**Advisory Action  
Before the Filing of an Appeal Brief**

10/754,394

WALSH, MICHAEL FRANK

Figure 1

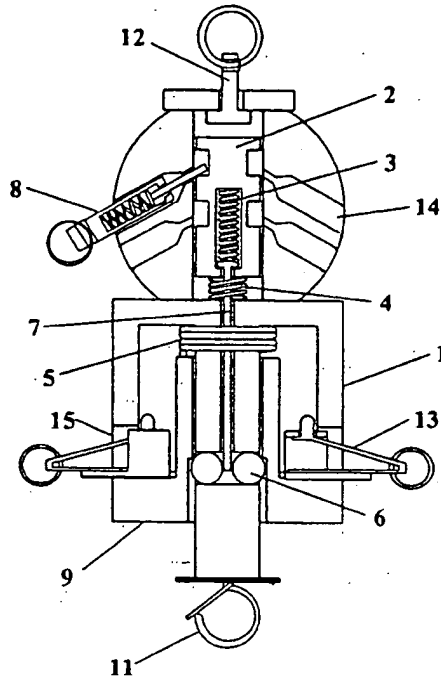
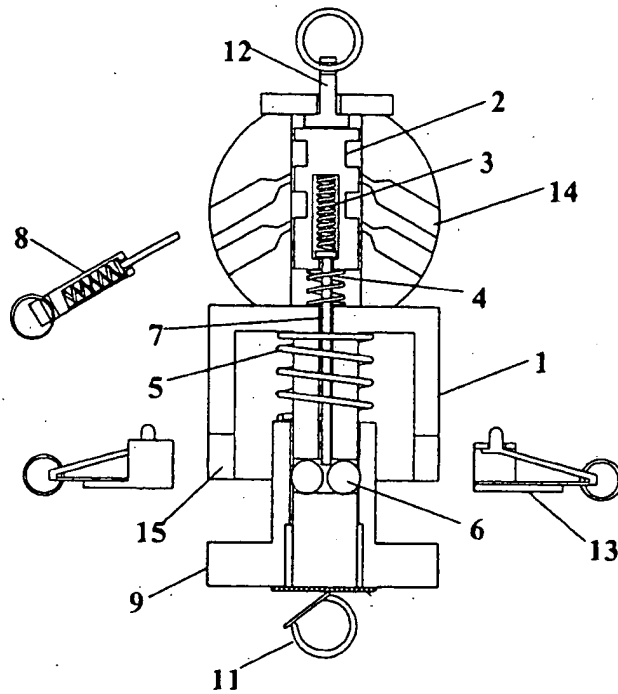
Continuation of 13. Other: Figure 1 needs to be broken into two figures such that the result renders Figure 1A and Figure 1B.

not accepted  
E.L.  
5/18/05

Figure 5

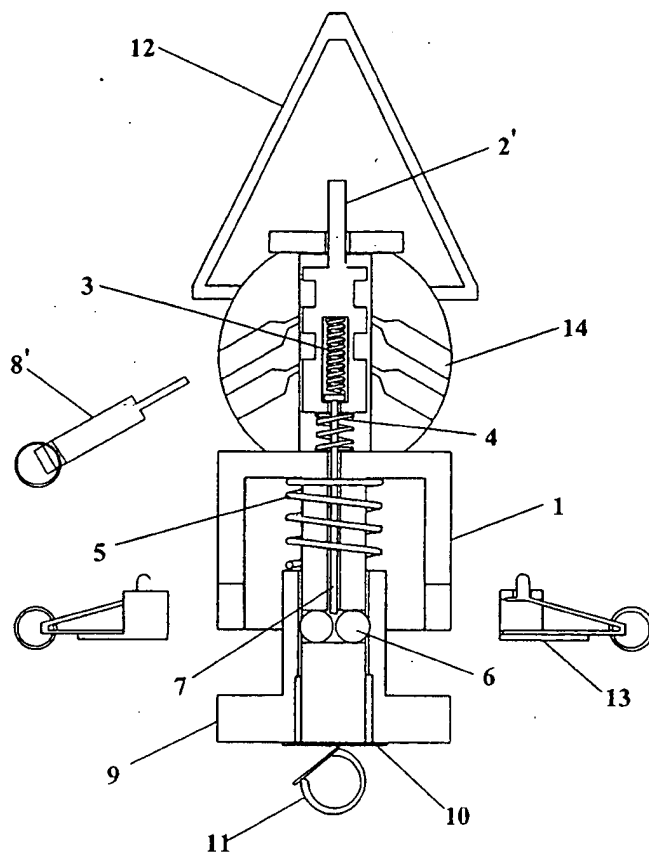
Accepted  
F.L.  
5/18/05
